June 27, 2017

Storage Rack Bracket Improvement

Figure 1: Various attachment options for Storage Rack Bracket

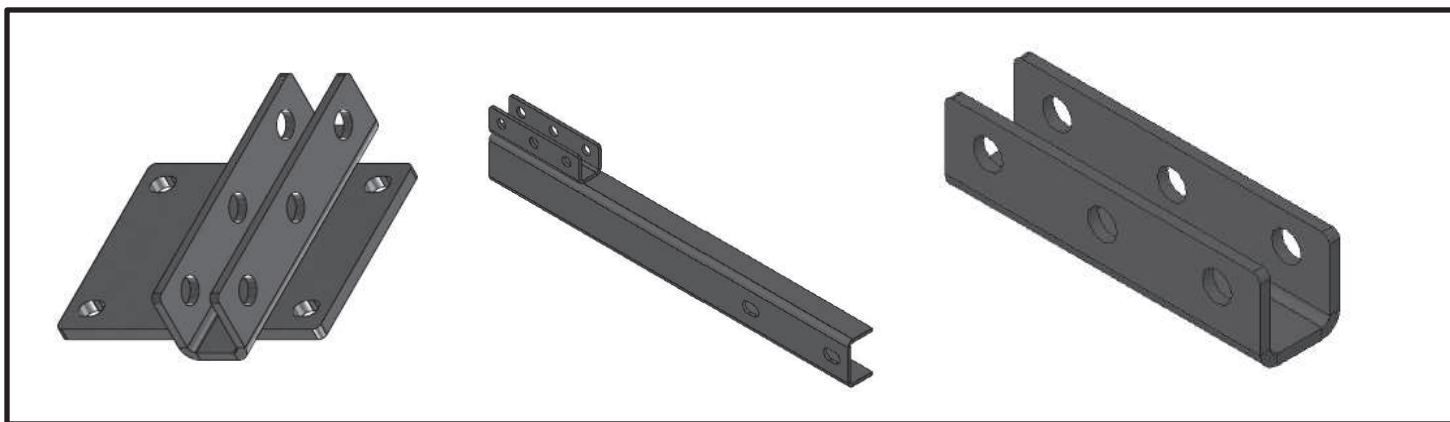
Please be advised that Lippert Components intends to transition its Storage/Bike Rack Bracket to an updated version with improved hole dimensions. The outside diameter of the holes will change from .530" to .515" and the center hole location in relation to the outside holes is offsetting by .060" (please see Fig. 2). This improvement will help with the hole to pin tolerances that allowed for a potential "droop" or "sagging" of the rack in the previous version.
